**INFORMAL GROUP ON GASEOUS FUEL VEHICLES  
Within the UN GRPE (WP29)**

CLEPA : European Association of Automotive Suppliers

Amendment on Regulation R83 and document GRPE Working Document ECE/TRANS/WP.29/GRPE/2012/6 regarding the use of petrol in gas mode and its limitation for bi fuel gas vehicles and the verification during type approval.

### **Proposal for an amendment to Regulation No. 83**

Figure 1: Comparison of fuel consumption measurement in the NEDC.

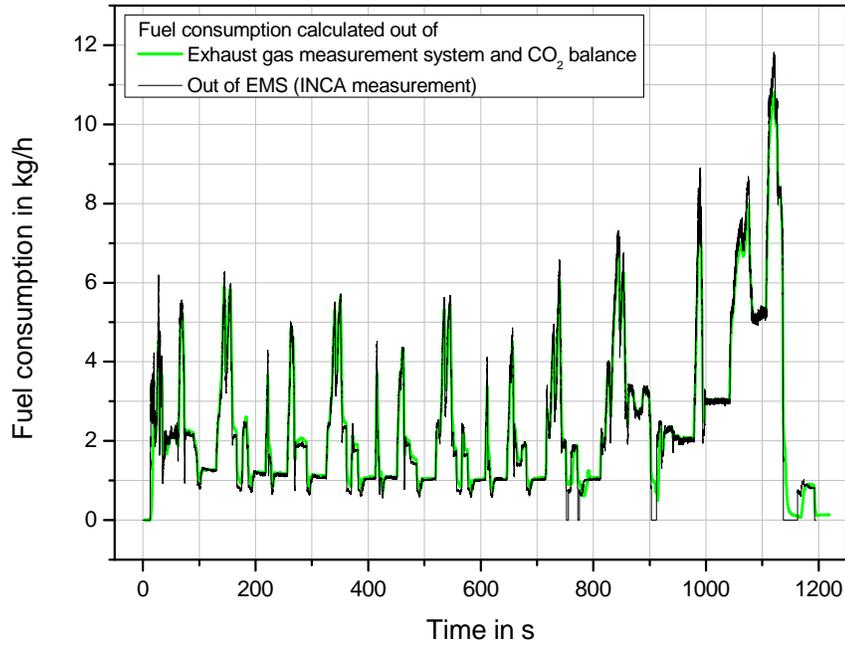
As an example, figure 1 is showing a comparison of fuel consumption measurement (modal data) in the NEDC for a vehicle equipped with a mono-fuel CNG engine.

- Firstly the FC was determined by the exhaust gas measurement system using the CO<sub>2</sub> measurement data (carbon balance method) in the test center.
  - Secondly the FC was calculated from the injected fuel mass in the engine control unit.
- It can be seen, that the results from both measurement systems show the same behavior.

Figure 2: Integrated values of fuel consumption measurement in the NEDC.

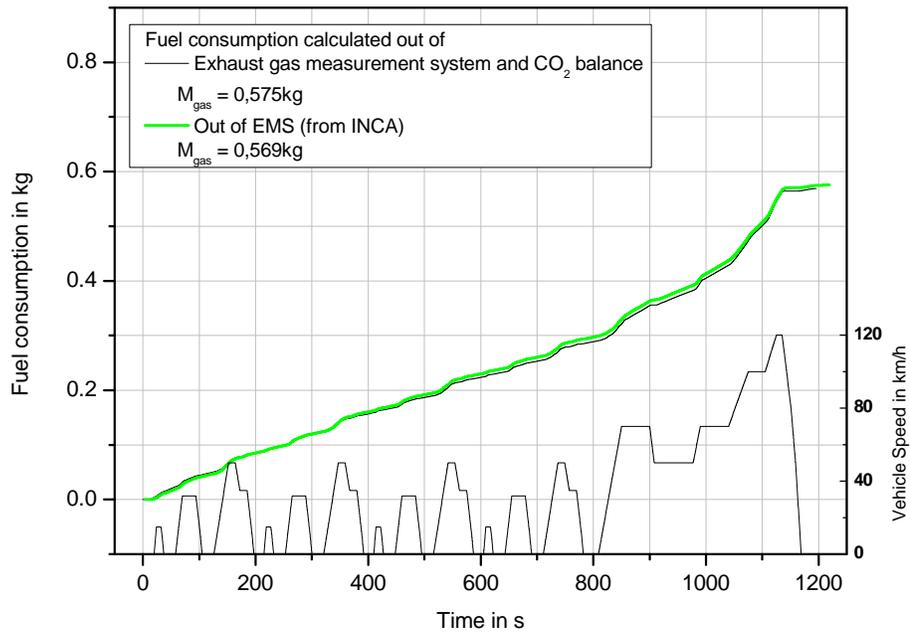
In figure 2, the modal FC values in kg/h were integrated to a total FC in kg over the whole cycle. Here it can be seen, that the deviation is below 2% of the overall injected fuel mass.
